SUNDRY NOTICES AND REPORTS ON WELLS (DO NOT USE THIS FORM FOR PROPOSALS TO DRILL OR TO DEEPEN OR PLUG BACK TO A DIFFERENT RESERVOIR. USE "APPLICATION FOR PERMIT" (FORM C-101) FOR SUCH PROPOSALS.)		WELL API NO. 30-015-22686

2. Name of Operator Chevron U.S.A. Inc.		6. State Oil & Gas Lease No.
3. Address of Operator 6301 DEAUVILLE BLVD., MIDLAND, TX 79706		7. Lease Name or Unit Agreement Name Williams Gas Com

Chevron USA INC respectfully requests to abandon this well as follows:

APPROVED BY: [Signature] **DENIED** DATE gc 8/17/2020

CURRENT TA WELLBORE DIAGRAM

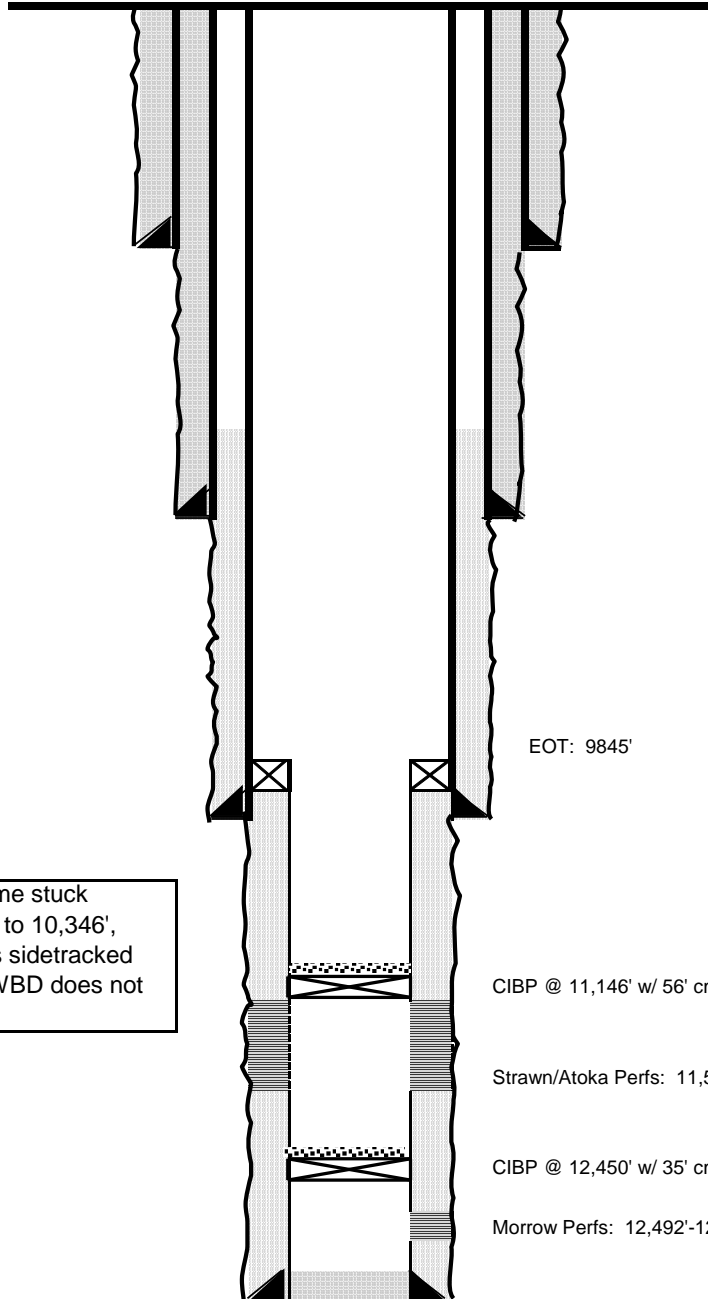
- TIH and tag CIBP cement cap at 11,090' **Need complete WBD**
 - Spot 130 sx CL "H" cement f/ 11,090' t/ 9,717', WOC and tag.
 - TOC must be at 9,725' or shallower.

Proposed TA WELLBORE DIAGRAM

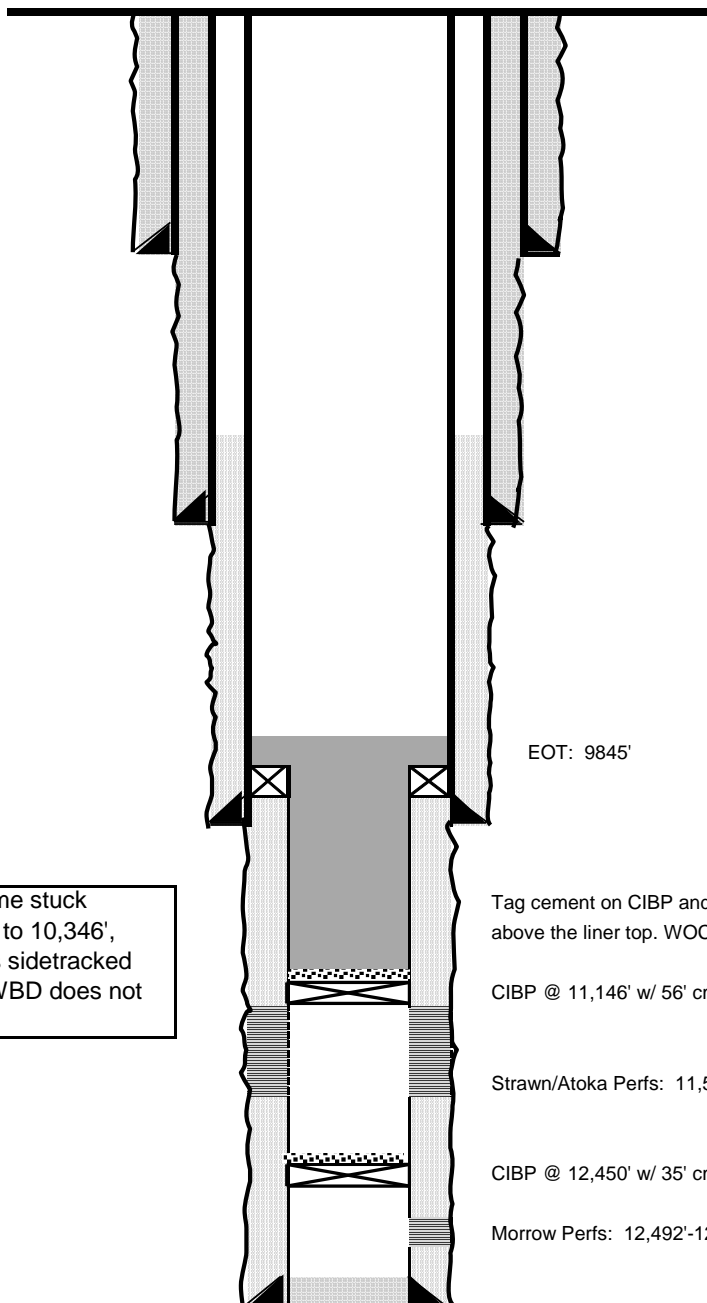
- Call and notify NMOCD 24 hrs before operations begin.
 - MIRU CTU. **Drill out cement & CIBP @ 11146**
 - Check well pressures, kill well as necessary. **Set CIBP @ 11470' w/ 25 sx cmt. (perfs. 11528'-11990)**

- N/U BOP and pressure test as per SOP. **Need procedure to plug to surface.**
 - 250 psi low for 5 minutes, and MASP or 500 psi, or highest expected pressure (whichever is greater) for the job for 10 minutes each.
